**ESP-TS1**

**TURBO SCSI CARD**

# FIELD CHANGE NOTICE

ASSEMBLY No. ESP-TS1 DESCRIPTION Turbo SCSI card

Rev 1.0  
 Rev 2.0 25/8/1992

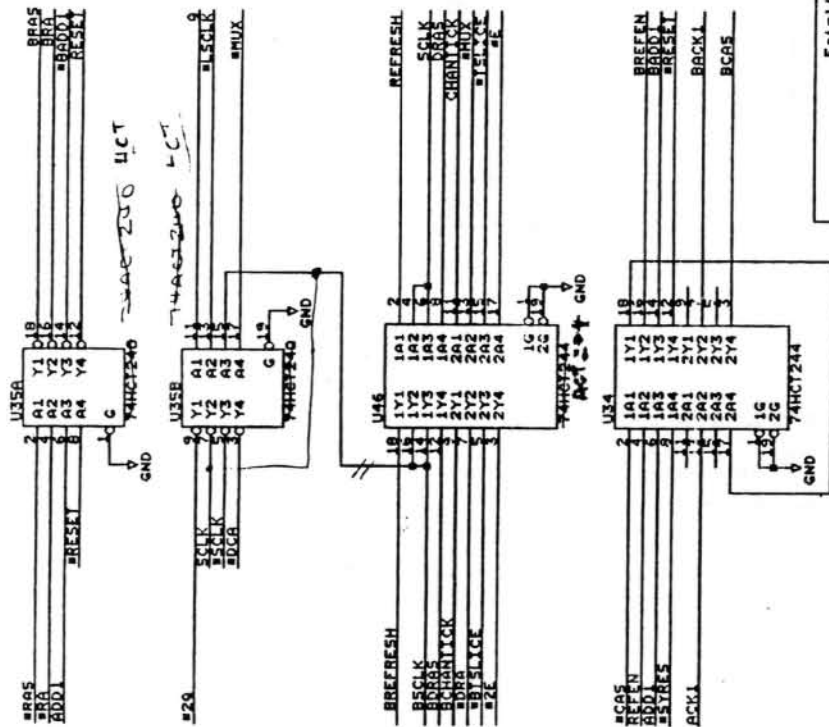
1. no trace connecting U33A to U33B  
 2. no trace connecting U33A to U33C

U46 to 74ACT244

pin 16 U33

to pin 3 U32

REV	1
Size	7 of 11
Document Number	TSCLAT.SCH
Date:	May 21, 1991
Sheet	7 of 11

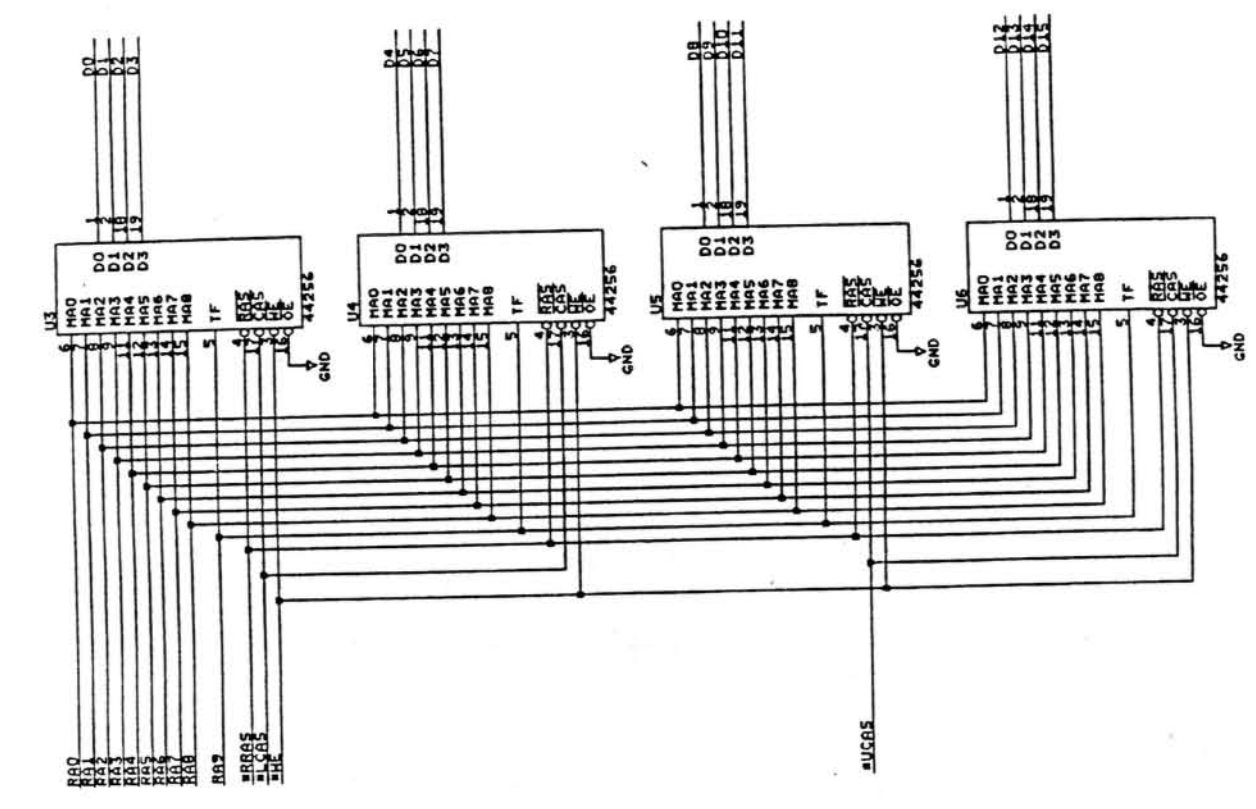
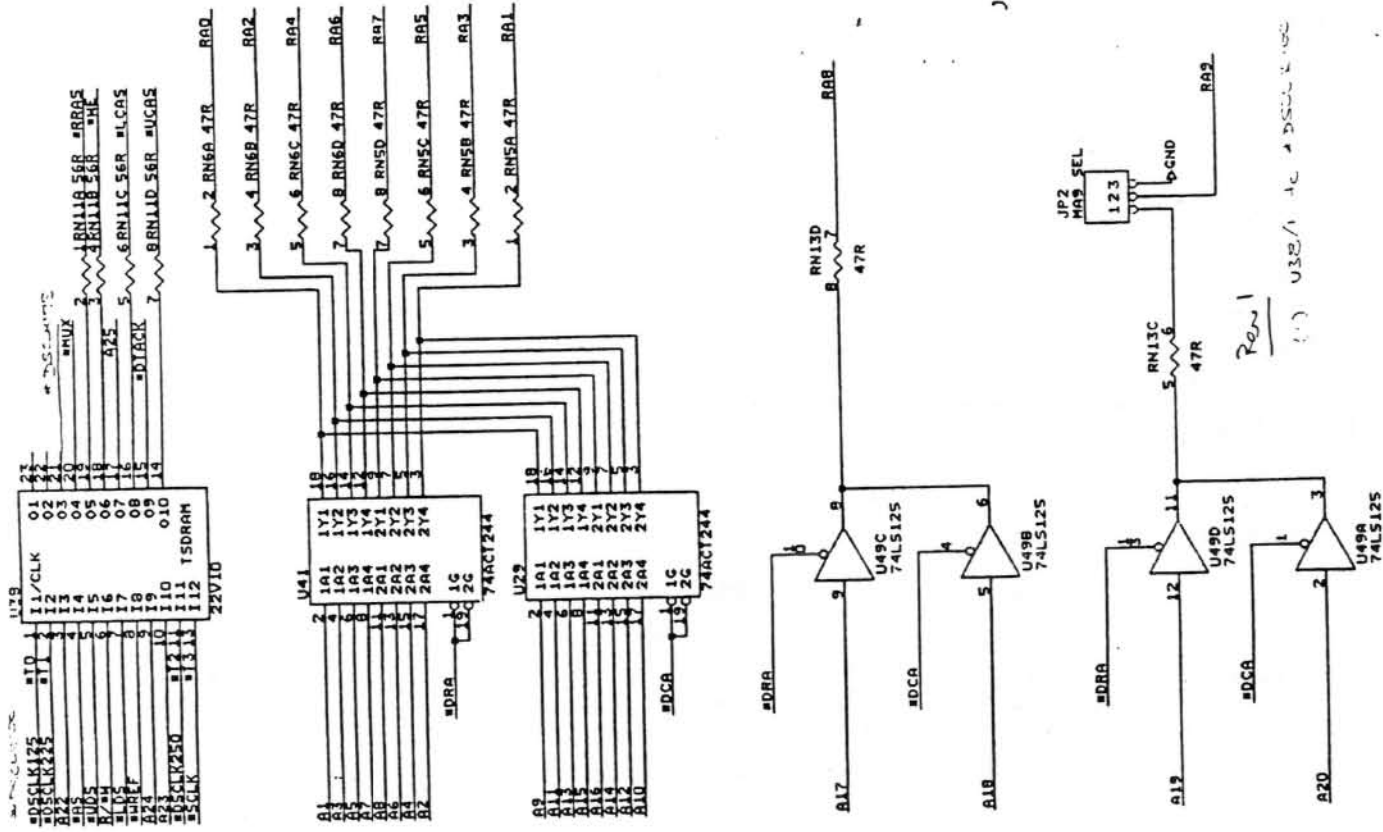
16/10/91 - TEST mode entered on bit CD3

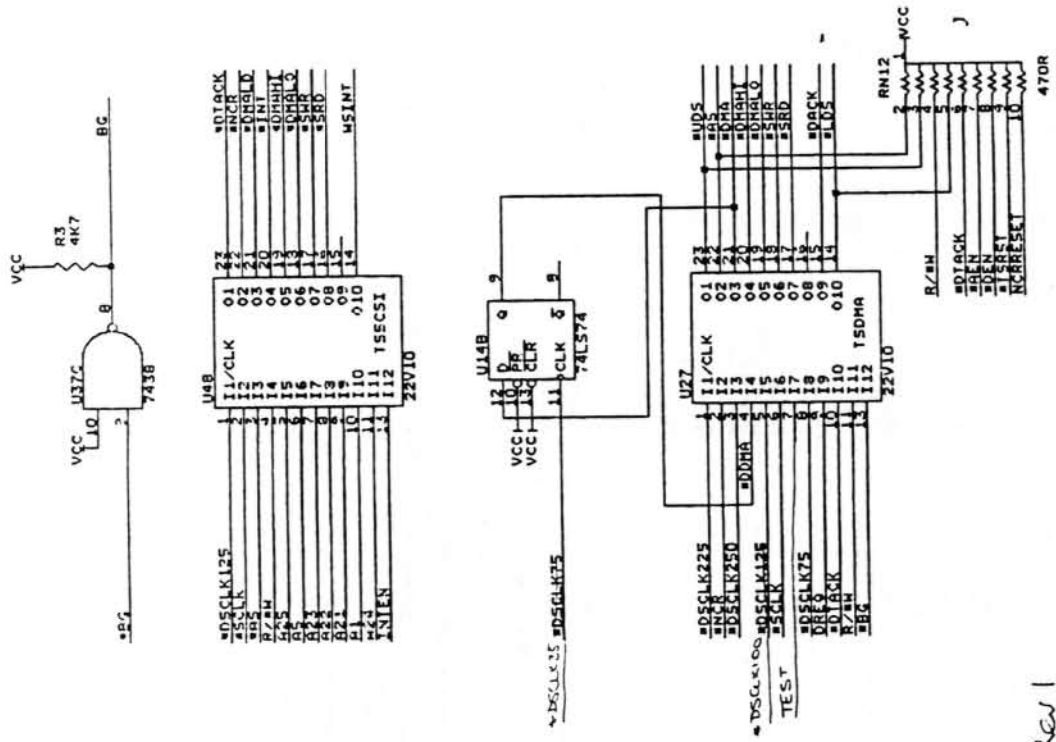
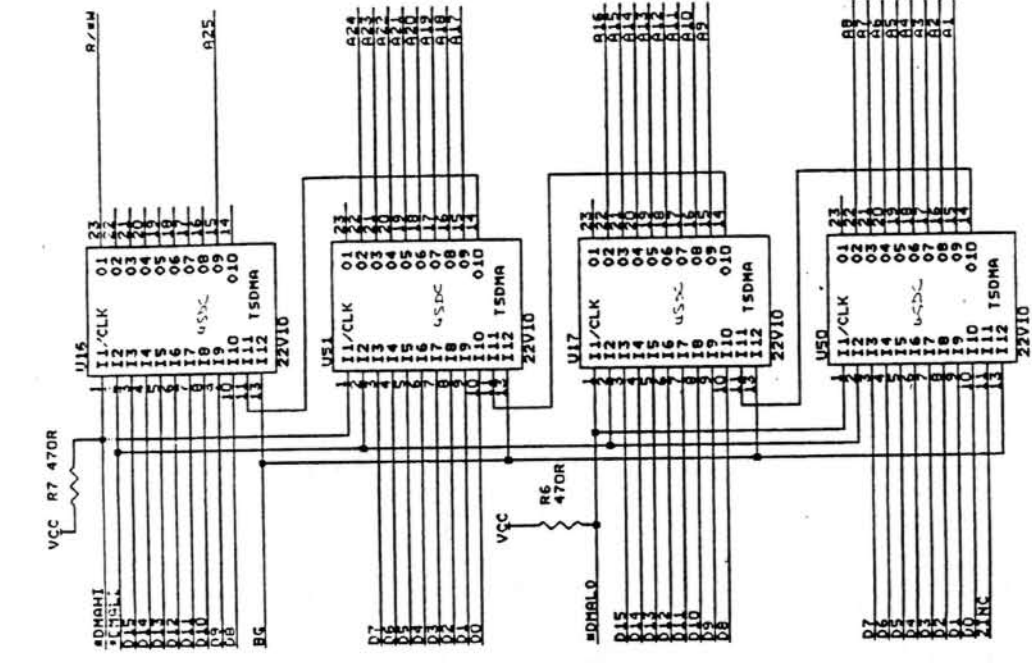
Rev1  
 10/10/91 - test input circuit to TSDMA.  
 20/1/92 - change DSCLK225 to DMHA on U17  
 Rev2  
 11/11/92 - change DSCLK225 to DRACK100 on U27
